CONSTRUCTION PLANS
FOR
**CARRIAGE MEADOW SOUTH AT
LORSON RANCH FILING NO. 2**
STREET/STORM SEWER AND UTILITY CONSTRUCTION PLANS

CORE ENGINEERING GROUP	DATE: _____
	DESCRIPTION: _____
NO. _____	PROJECT: CARRIAGE MEADOWS SOUTH AT LORSON RANCH FILING NO. 2
DRAWN: RLS	PREPARED FOR: LORSON, LLC
DESIGNED: RLS	212 N. WAHSATCH AVE. SUITE 301
CHECKED: RLS	COLORADO SPRINGS, COLORADO 80903
COVER SHEET STREET/STORM SEWER AND UTILITY PLANS	
DATE: DECEMBER, 2018	
PROJECT NO. 100.046	
SHEET NUMBER C0.1	
TOTAL SHEETS: 21

SHEET NUMBER
C12.1

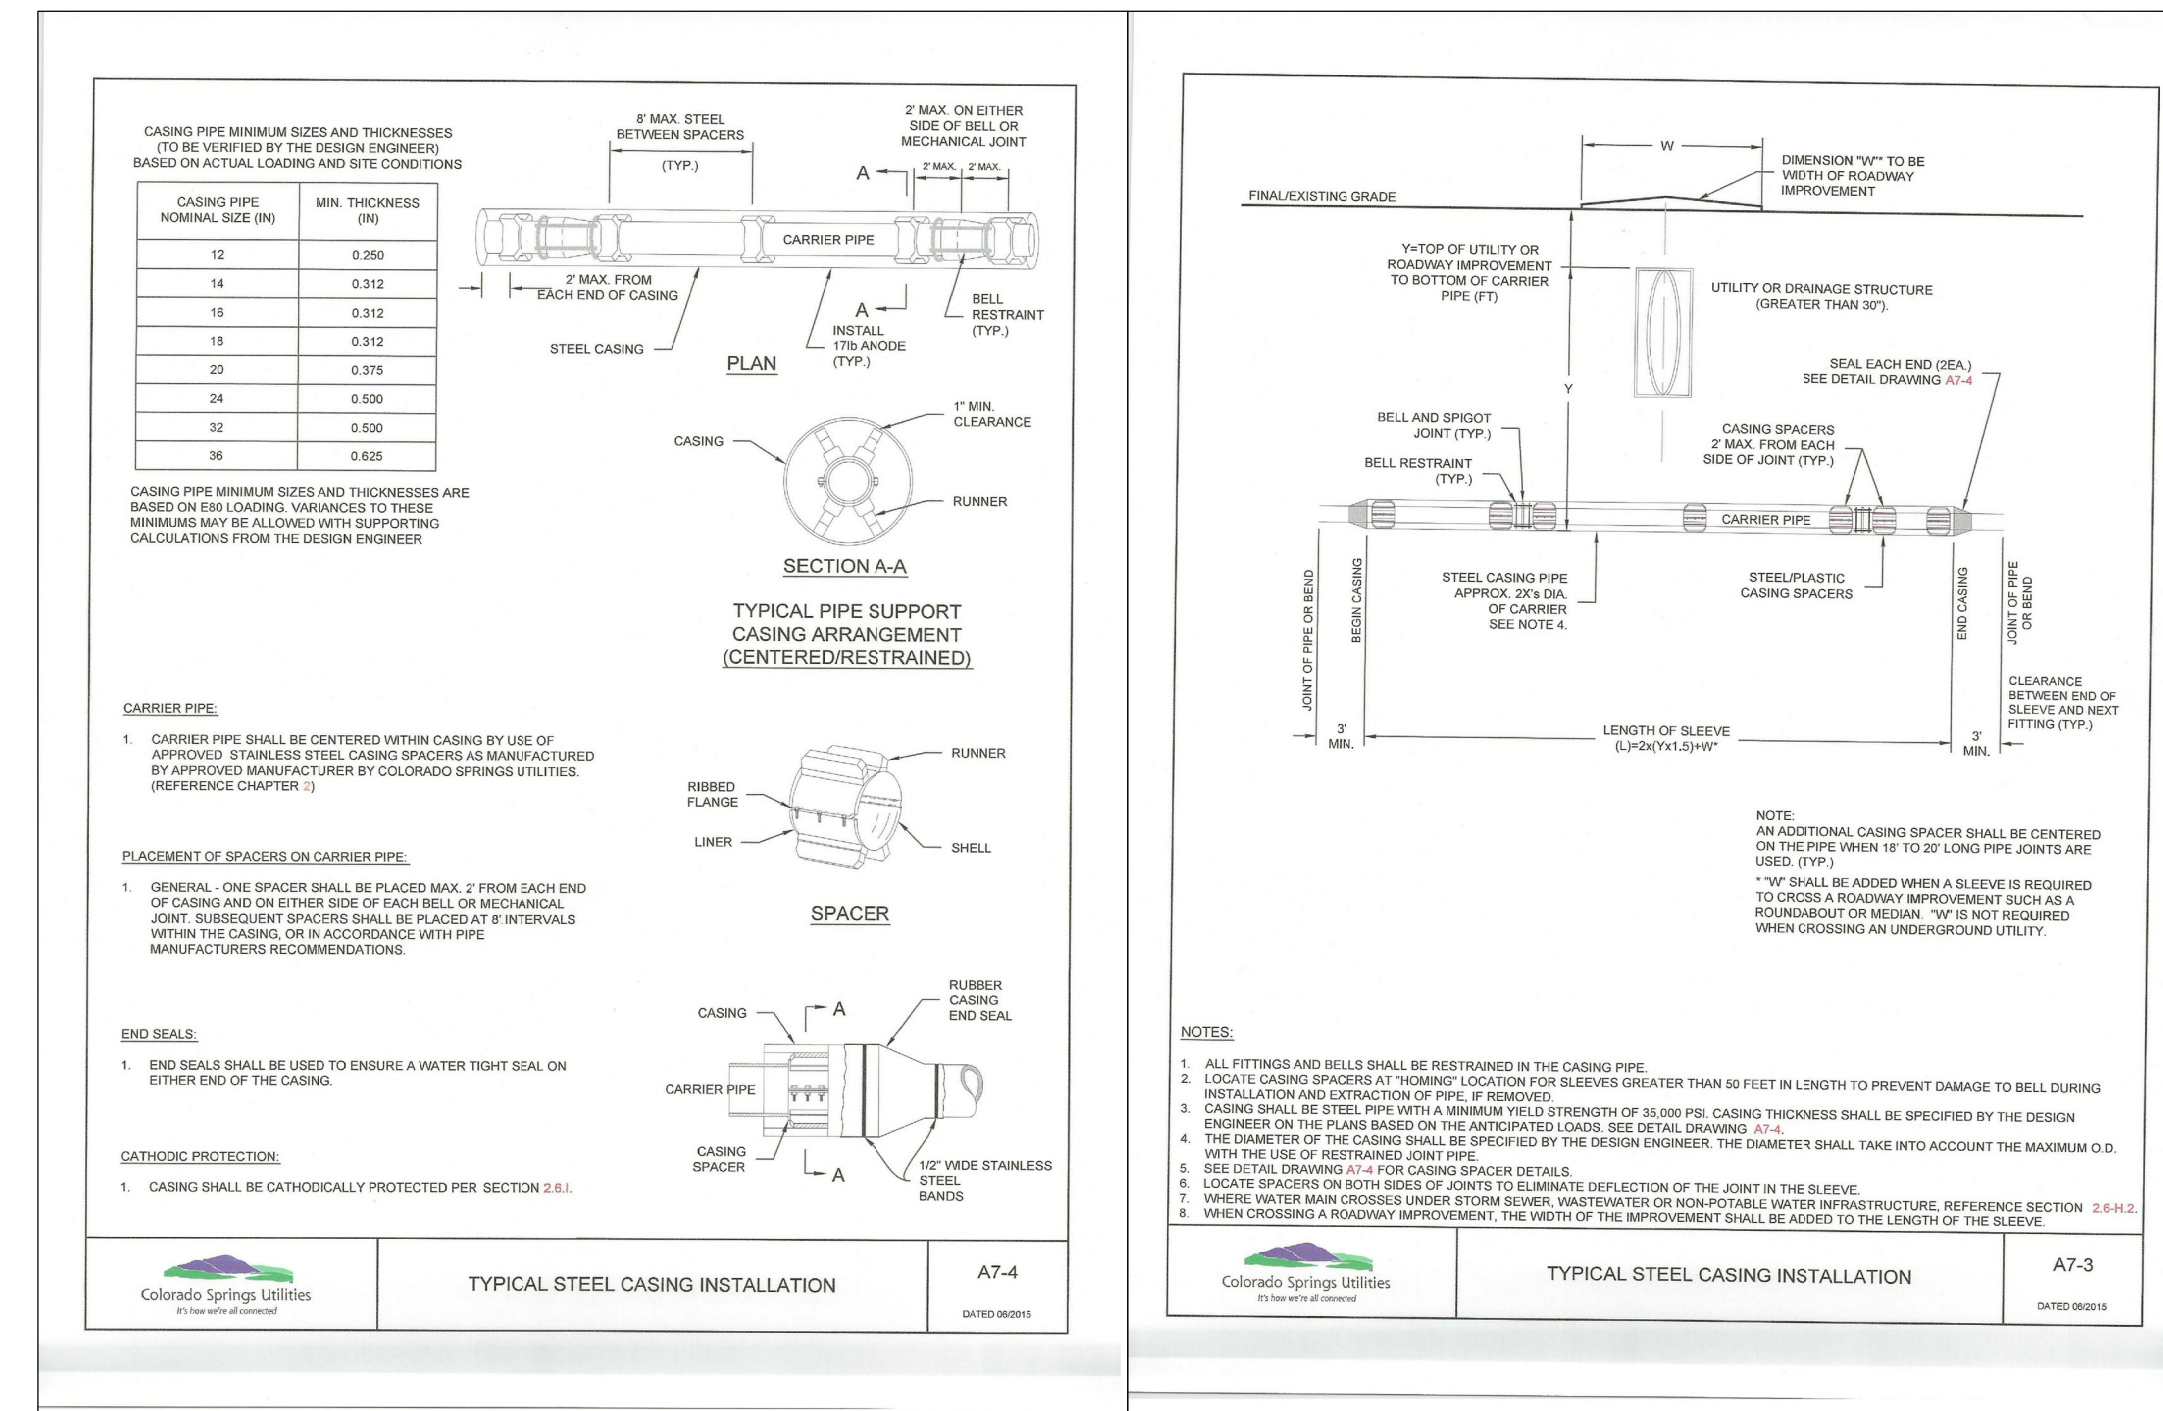
Please expand the size of these 10 details so they cover evenly these two plan sheets. We would like to be able to have the printed out and read on an 11 X 17 paper.
